CONSERVATION COMMISSION AGENDA

Date: May 4, 2021

I. WETLANDS DECISIONS

AGRICULTURAL RECLAMATION PLAN
PREPARED FOR:
MATTHEW S. SOSIK AND JANICE K. SOSIK
SITE LOCATION:
126 ARNOLD ROAD
STURBRIDGE, MA 01566
DEP FILE NO. 300-1094
PLAN DATE: 01/16/2021
DWG NO: 287-086
C-01
SHEET 1 OF 1
REVISION 2

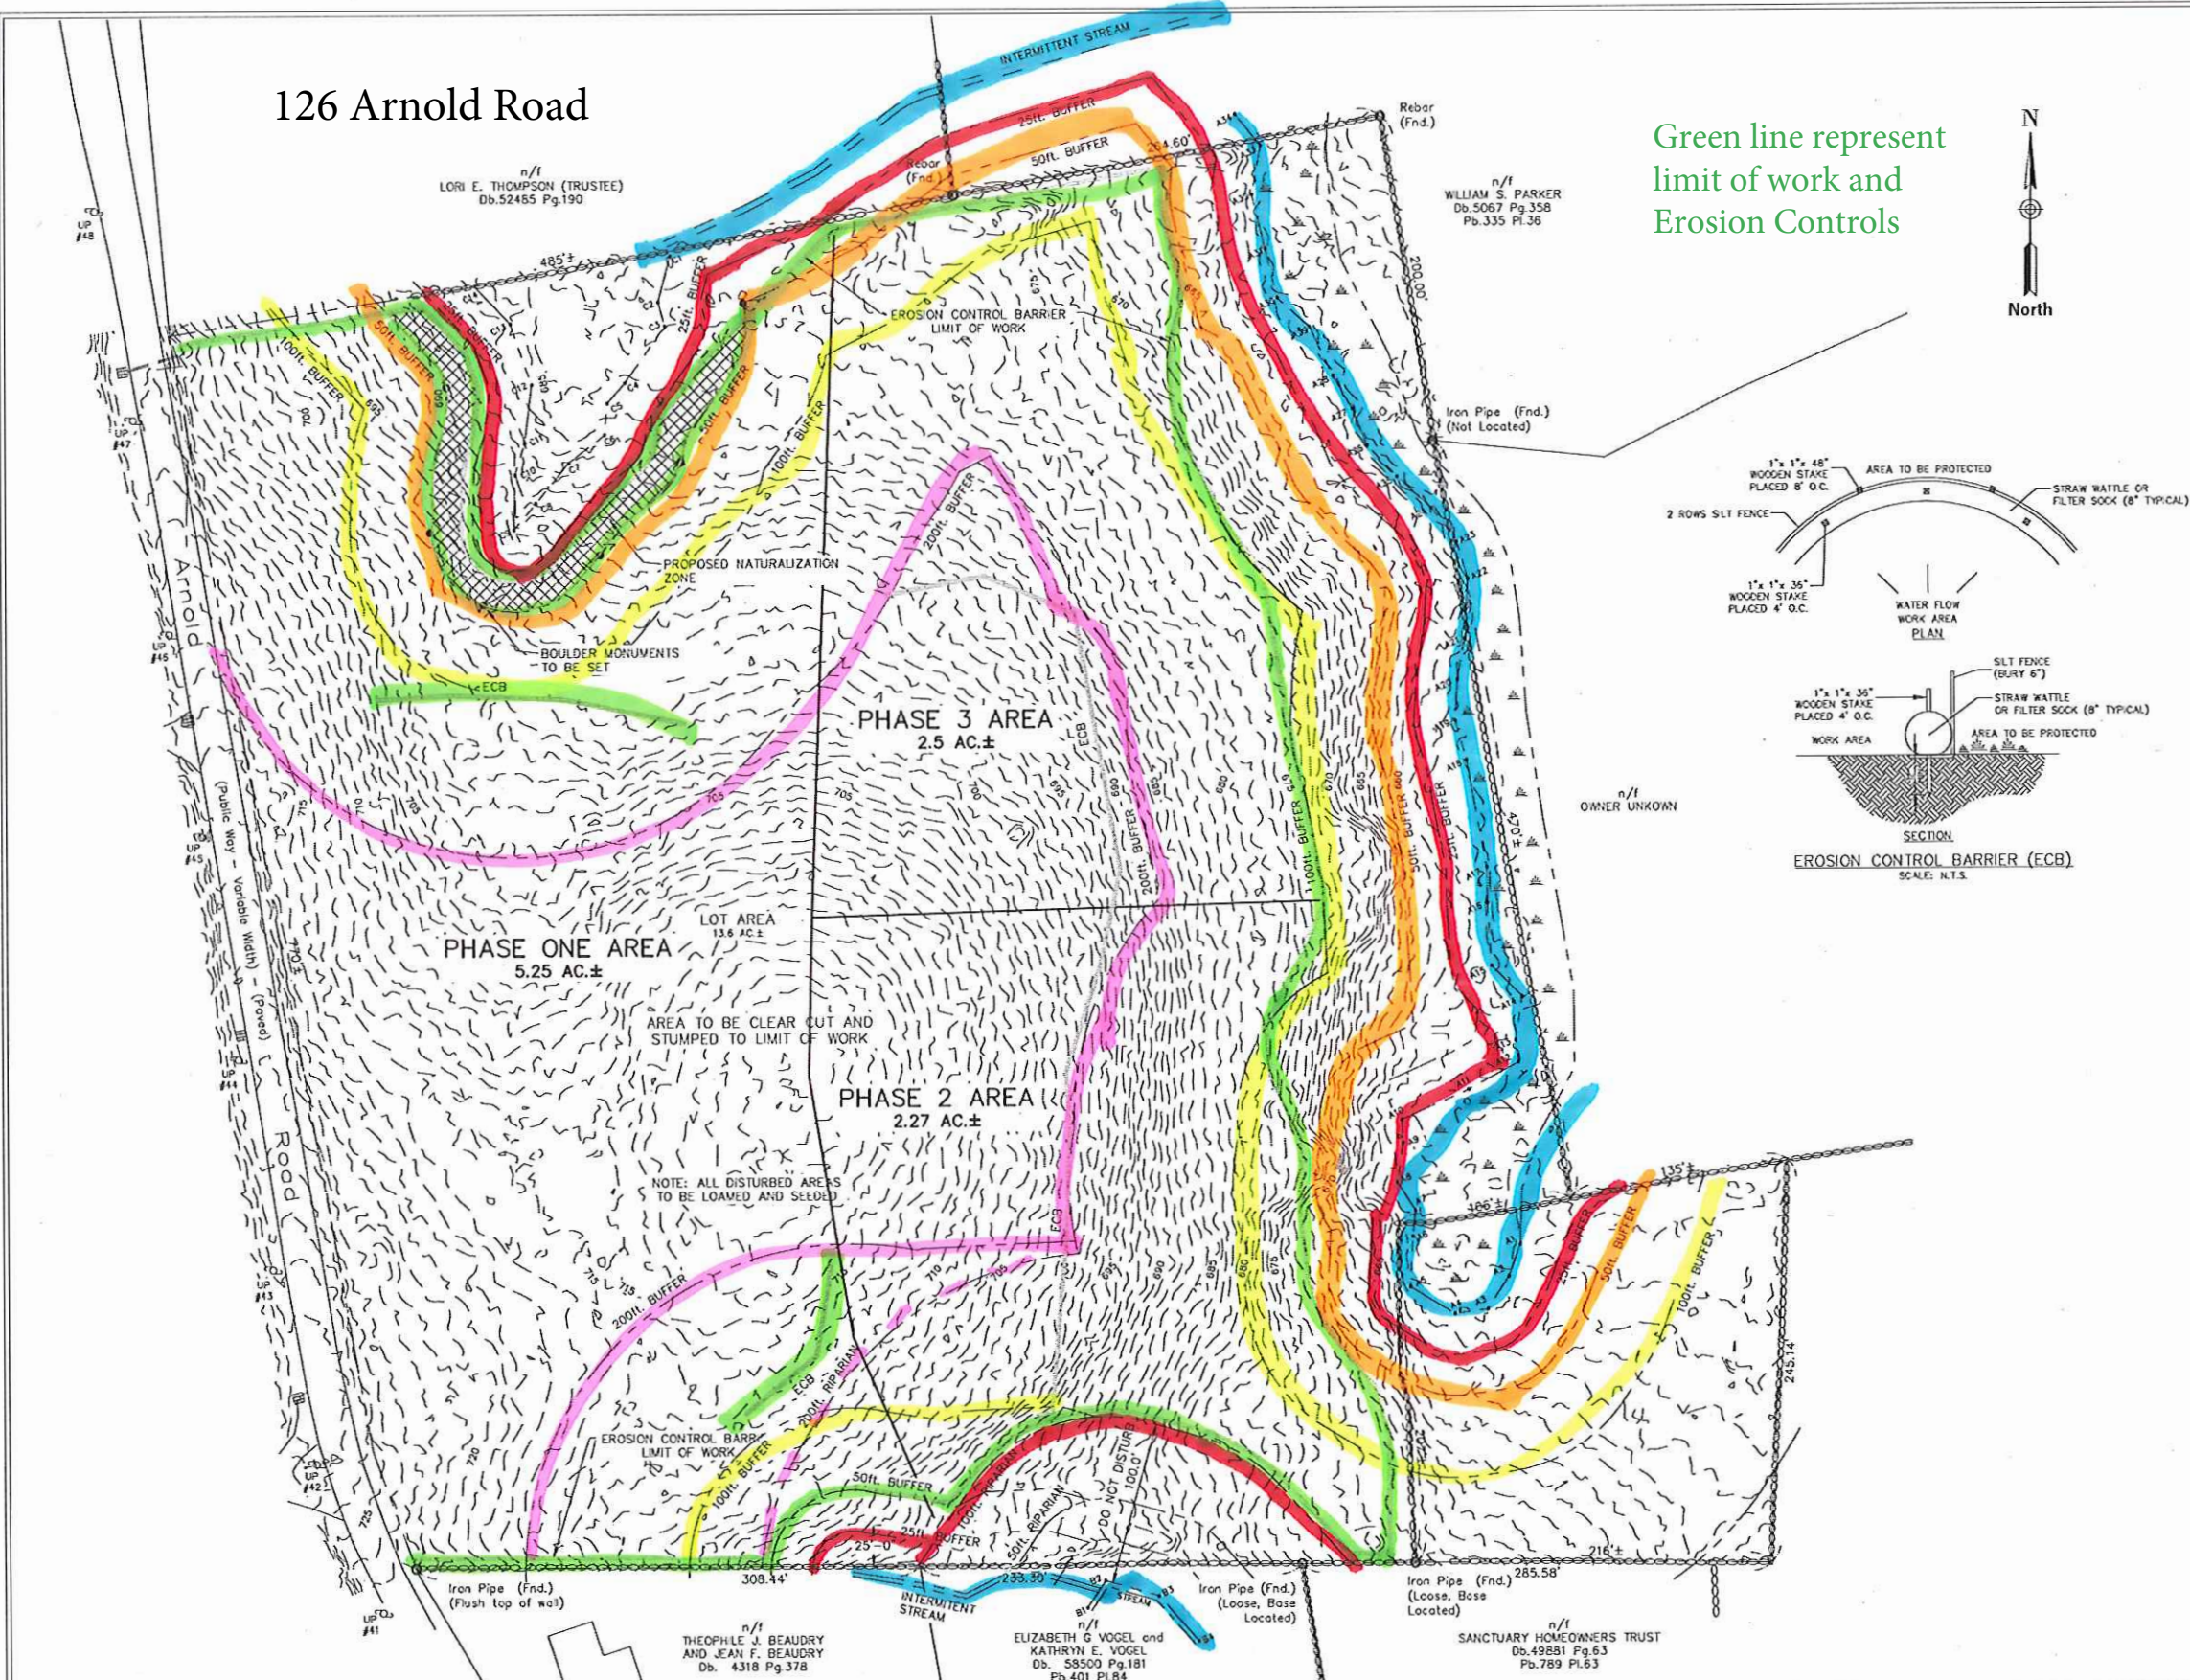
- Staff Notes:
 - Written comments from an abutter received. Included.
 - Project was revised to incorporate board and staff comments.
 - Areas of selective cutting removed near the A series wetland (northern wetland) and limit of work shifted from the original proposal to approx. 100 ft in some areas;

- Limit of clearing moved near the C series wetland (north). LOW was not shifted for the intermittent stream in this area. Small section enters the 50 ft BZ and extends to the 25 ft BZ.

- Proposed naturalized area shown between 25 to 50 ft BZ along the C series wetland. Applicant proposes to clear area but not stump to provide sunlight to western proposed agricultural area. Boulders will be set in place at the 50ft BZ here.

- Intermittent stream noted on plan vs. drainage swale as instructed on the southern property boundary. LOW revised to 50 ft as requested.
 - P.E. stamped plan received.

- SWPPP submitted to EPA and project plans reflect phasing to the project to minimize areas of disturbance open at one time.
 - Naturalization Zone: The applicant has indicated “that there are actually very few trees within the 25-50’ zone and most trees that are within that area are outside of 35’. I believe having the permanent buffer zone of 50’ is a nice compromise. To your concern, that wetland will continue to be heavily treed via the trees that are inside the 25’ buffer (and those that are inside the BVW itself). Those trees are mature and healthy and will continue to provide a lot of shade to the wetland itself.”

- Use of outer Riparian (Riverfront Area) is allowable provided that an agricultural commodity is being produced. If a commodity is not proposed to be produced here than use/conversion of the area must meet the performance standards for 321 CMR 10.58.

- If the board is satisfied with the revisions, staff recommend that the project is approved with the following conditions:
 - Standard construction conditions.
 - Approved SWPPP prior to the start of work.
 - Perpetual conditions should be noted for RA agricultural and any potential conversion to other uses. Any proposed changes and/or work would require a new NOI filing and would have to meet the performance standards for 321 CMR 10.58.
 - Additional standard perpetual conditions should be noted for herbicide, fertilizer and pesticide use; additional alterations, no dumping, no sedimentation into wetlands, etc.

231, 233 & 235 Cedar St Jalbert Flaggging

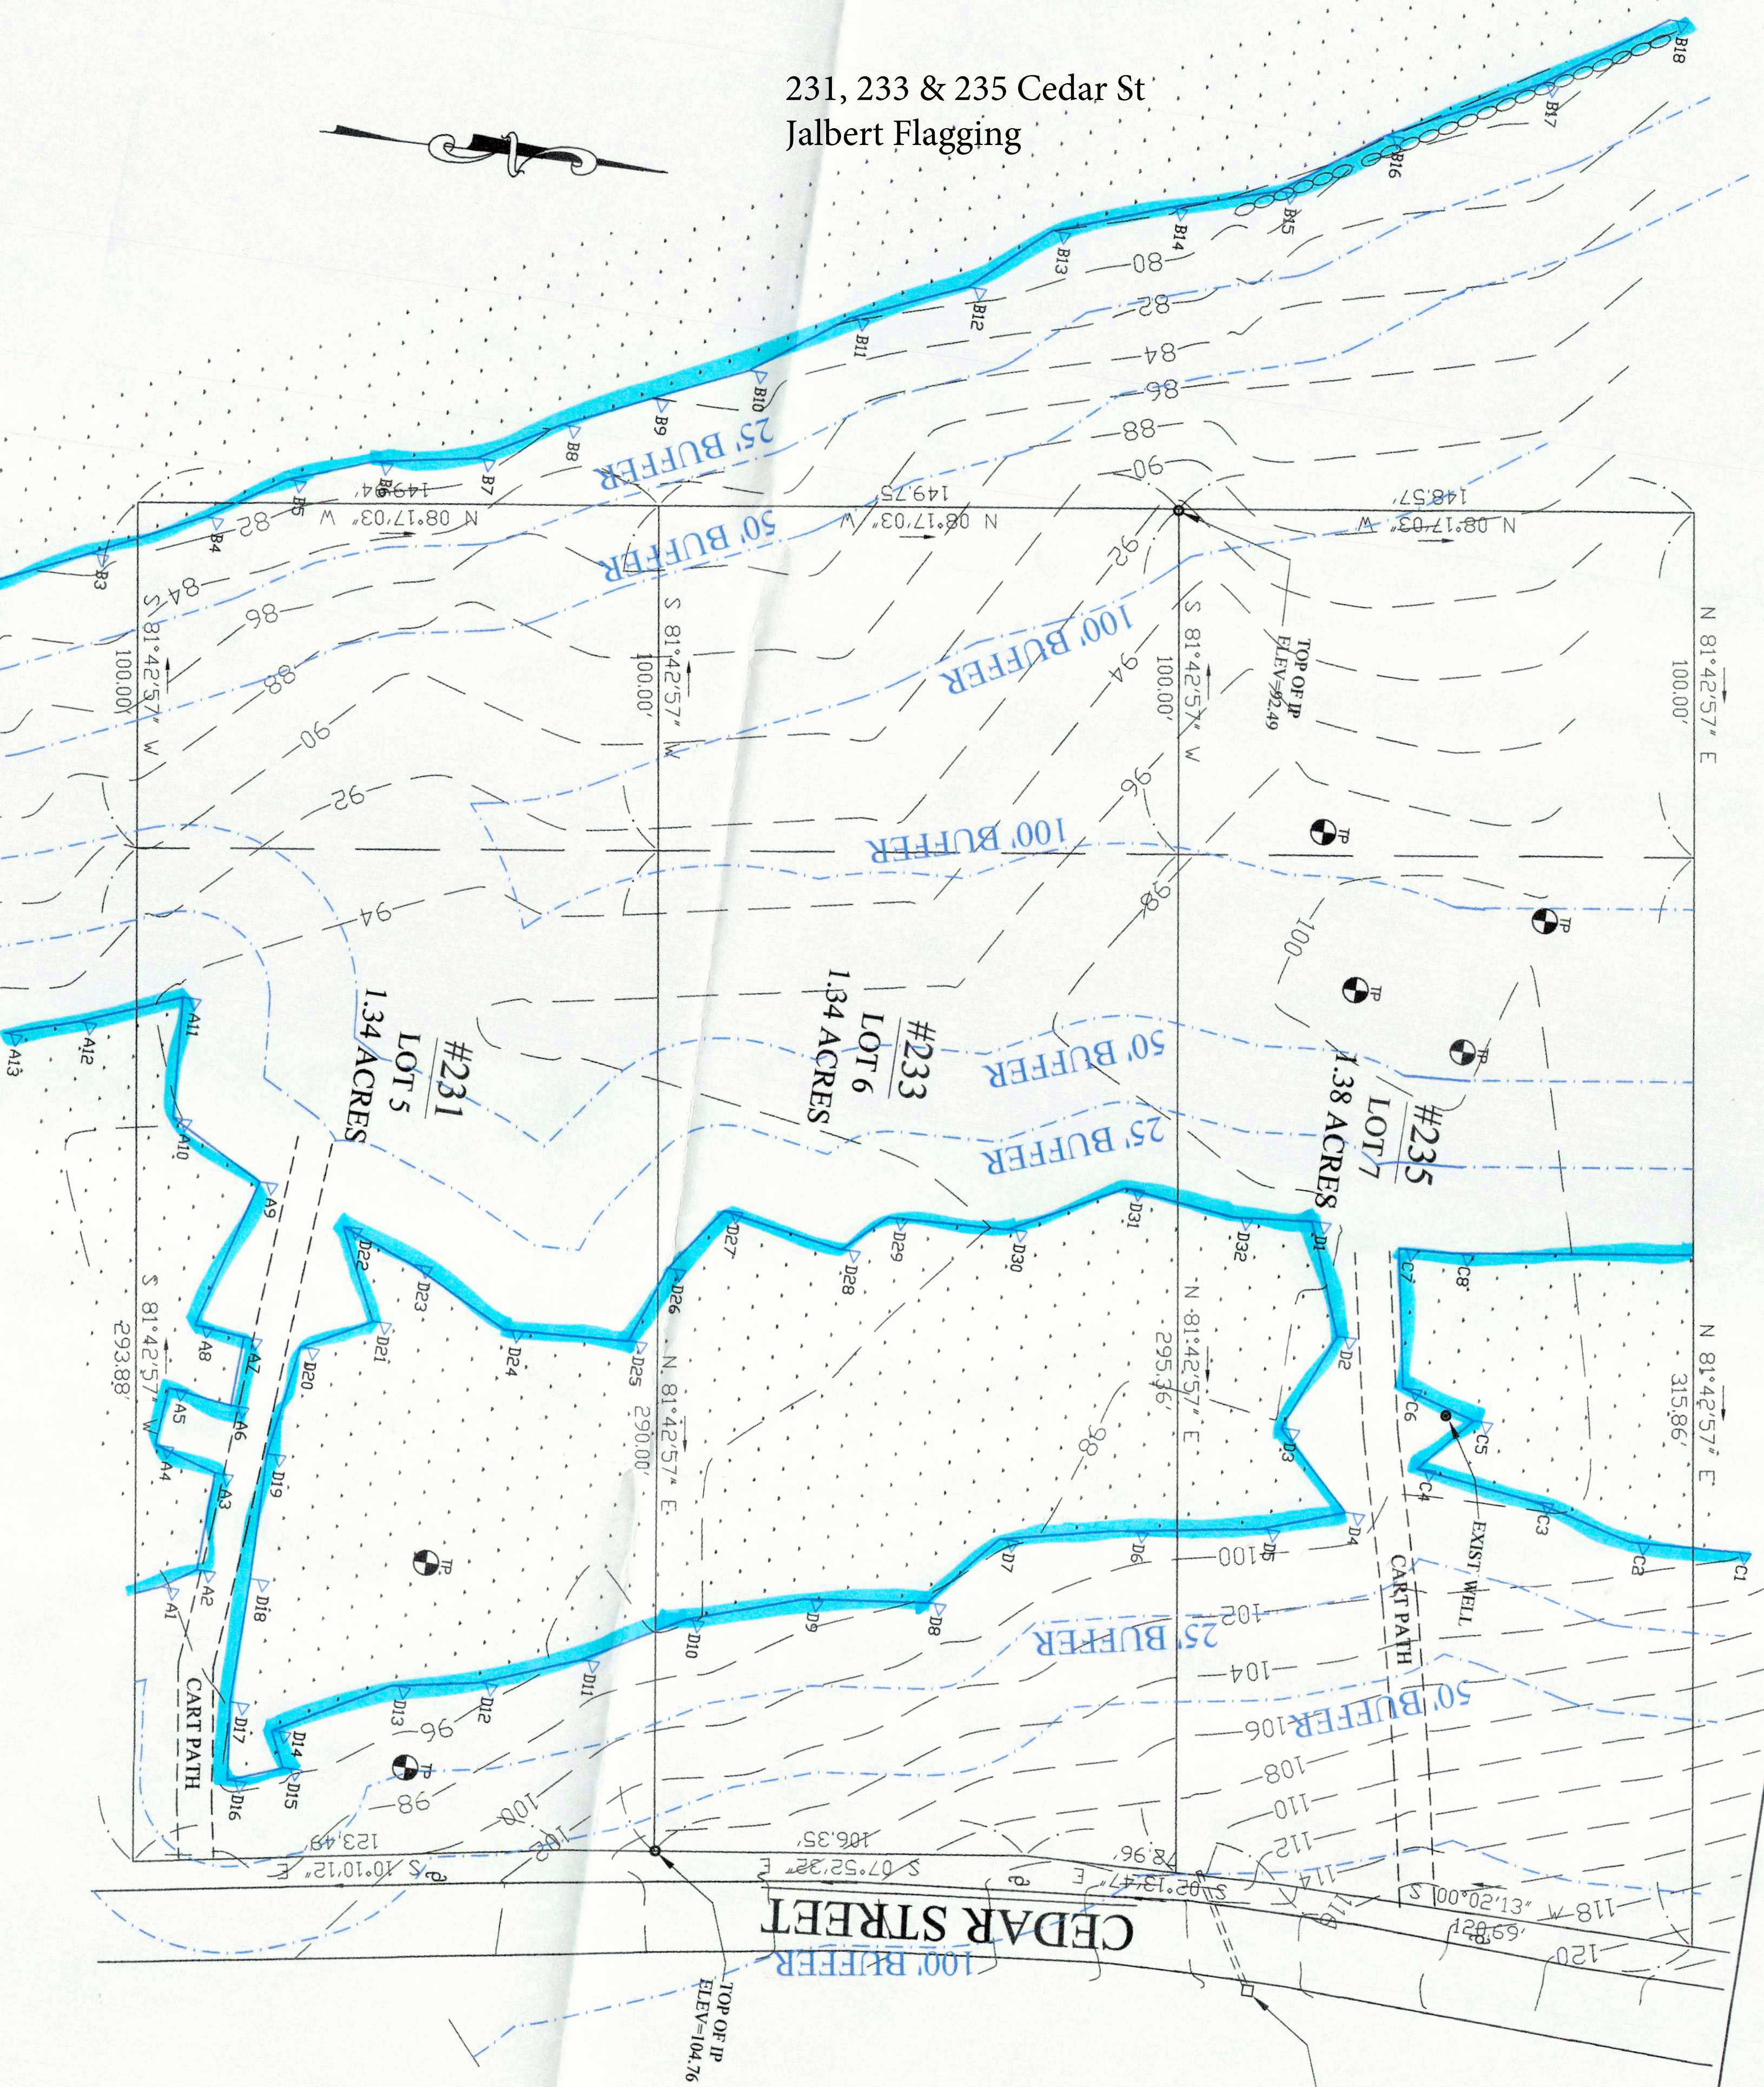
- Wetland flag revision requested at the site visit.

- A pipe must be installed under the driveway for 237 Cedar St. to keep the hydrological connection with the BVW.
 - Remove pipes which from the front wetland to the rear wetland as proposed.
